TULSA METROPOLITAN AREA PLANNING COMMISSION

For Meeting No. 2471

February 21, 2007

SHIPLEY SUBDIVISION

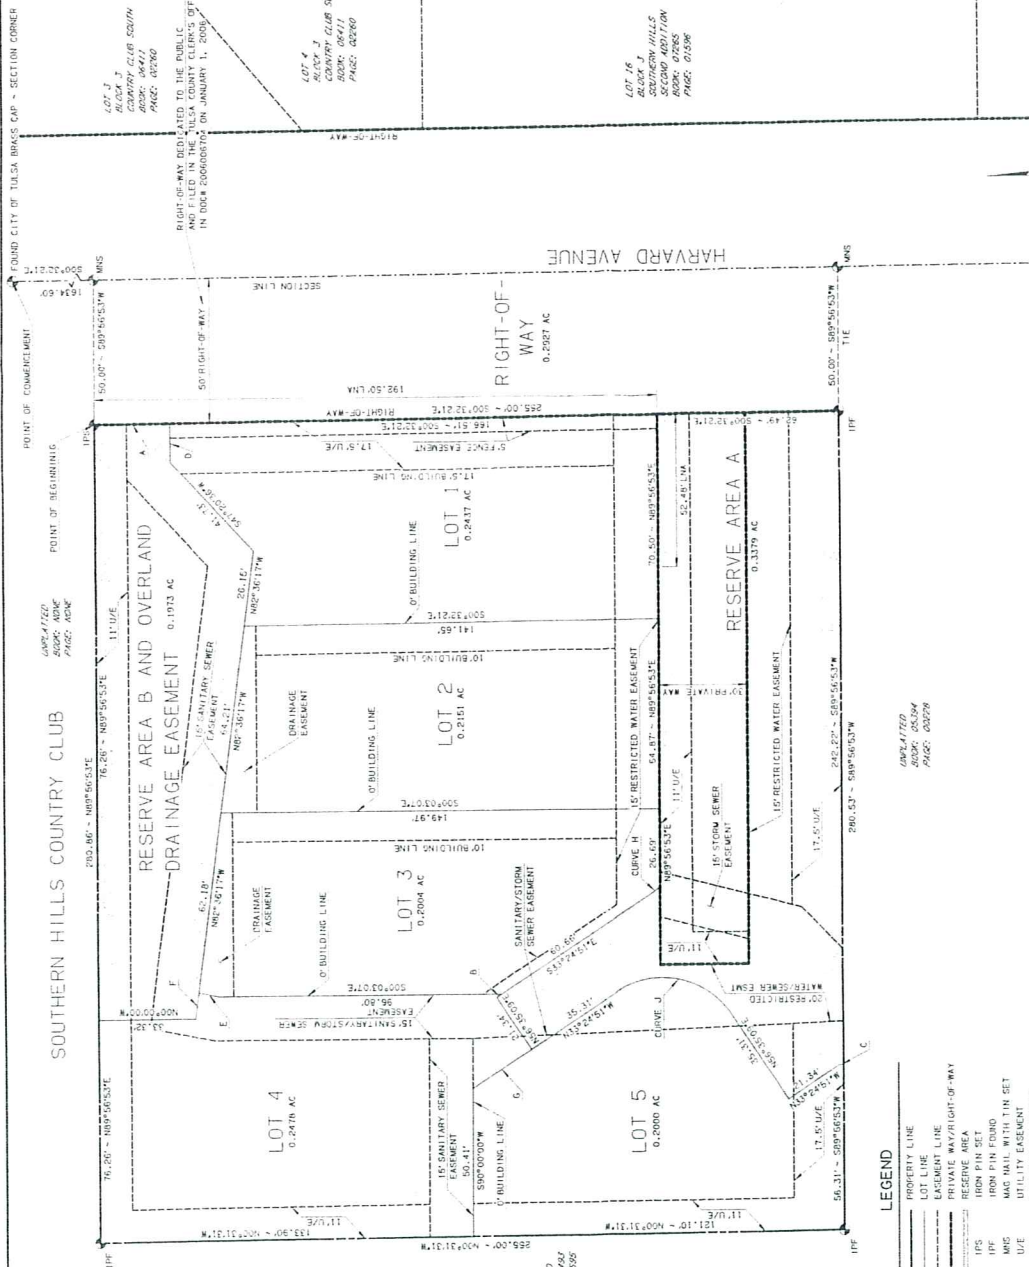
The following issues were discussed November 16, 2006 at the Technical Advisory Committee (TAC) meetings:

1. **Zoning:** The property is zoned RS-1 with PUD 735 pending (11/15/06). (The plat has been continued from 12/6/07, 1/3/07, 1/17/07, 2/7/07 to allow for City Council to review and approve the PUD standards.) City Council approved PUD 735 on 2/1/07 per Planning Commission recommendation. The PUD approval includes Mr. Albertys' verbiage as follows: Mr. Alberty reiterated that the sidewalk requirement would remain in effect or a suitable arrangement made for a contribution to a sidewalk fund in the PUD. That doesn't address which way we are going at this point, but it keeps the options opened. When the subdivision plat comes through, then there will have to be the same type of provision at that point. Mr. Alberty concluded that he doesn't want this PUD to be approved by waiving the sidewalk requirement. Sidewalk construction on Harvard Avenue will be waived in-lieu of comparable contribution of the costs of sidewalk construction to Public Works Sidewalk Escrow account.

2. **Streets:** Revise the building line to 20 feet and show as a "slope easement" per PUD. Language will be required for the 20 foot slope easement from the east boundary line to the building line, and overlapping the utility easement, to ensure the ultimate 5 lane. Harvard can be constructed within the MSHP 50 foot west side right-of-way while allowing a structure to be built at the designated building line, that the slope within that easement be no steeper than 3:1 (horiz:vert). The removal and replacement of the existing security fence, or its relocation to the slope easement, which is in place by agreement with the Southern Hills Country Club to the north, will be the responsibility of the owner. The existing trees and security fence are allowed to remain in the Harvard right-of-way and will require a license agreement with the City of Tulsa. Subdivision Regulations require sidewalks. The City will accept a payment to the City for the cost of construction of a sidewalk on Harvard in lieu of the developer constructing a sidewalk at the time of constructing the subdivision's infrastructure. The cost will be calculated from the Engineering Services Permit worksheet. If sidewalks are not required on the private street, per PUD, then a waiver by the TMAPC will be required. Dimension the "Limits of Access" on Harvard per the PUD site plan. Include language for the maintenance and ownership of the reserve and/or private street.

3. **Sewer:** In the easement area located east of Lot 5, you must define the easement boundaries. I cannot determine where the 15 foot sanitary/storm

sewer easement ends and the 20 foot water/sewer easement begins. The same goes for the 15 foot restricted water easement and the 20 foot restricted water/sewer easement. Define what restrictions are placed on the various sanitary, storm sewer, and water easements. Describe Reserve Area "A" as well. The proposed off-site sewer line should have been included in the conceptual plan as well as on the on-site. Where are you going to tie in to the existing sewer?

4. **Water:** Clarify easements on the west end of roadway.
5. **Storm Drainage:** The off-site overland drainage, which flows onto the site from the south, must be conveyed in an overland drainage easement from the south boundary lines for the storm and sanitary sewer easements as they cross the restricted waterline easement. Fifteen feet is a minimum width for a public storm sewer easement. An easement with both sanitary sewer and storm sewer in it must, at a minimum, be placed in a 17.5 foot wide utility easement. Underground detention facilities must be placed in stormwater detention easements. The additional drainage from Reserve Area A is piped and discharged directly into Reserve Area B. Does Reserve Area B provide some stormwater detention for this additional drainage? Add language to explain the use and maintenance responsibility for each reserve area. Add standard language to explain the use and maintenance responsibility for each reserve area. Add standard language for underground stormwater detention facility maintenance, overland drainage easement, water mains, sanitary sewers and storm sewer services.

6. **Utilities: Telephone, PSO, ONG, Cable:** It was determined that a separate meeting would have to be held with the utilities to make sure of placement of lines and adequate easement location and size. (This meeting has been held and further coordination with the utilities is underway.)

7. **Other: Fire:** Fire Chief shall approve the installation of security gates across a fire apparatus access road. Where security gates are installed, they shall have an approved means of emergency operation. The security gates and the emergency operation shall be maintained operational at all times.
GIS: Complete the location map. Add dimensions on inside of boundary between easements. Include the bearing with the basis of bearing. Place the PUD number under the Title. Correct the dimension of the north line of Reserve B or Reserve A easements, as shown, are unacceptable. Due to the short time span between the PUD approval (11/15/06) and the TAC review of this preliminary plat, it is therefore noted that all conditions of approval of the PUD shall apply and be incorporated in the plat, even though some of those conditions may not be explicitly referenced in these comments for the preliminary plat. Accurately describe the location of the

tract under ownership in the legal description and in the title.

Staff recommends **APPROVAL** of the Preliminary Subdivision plat subject to the TAC comments and the special and standard conditions below.
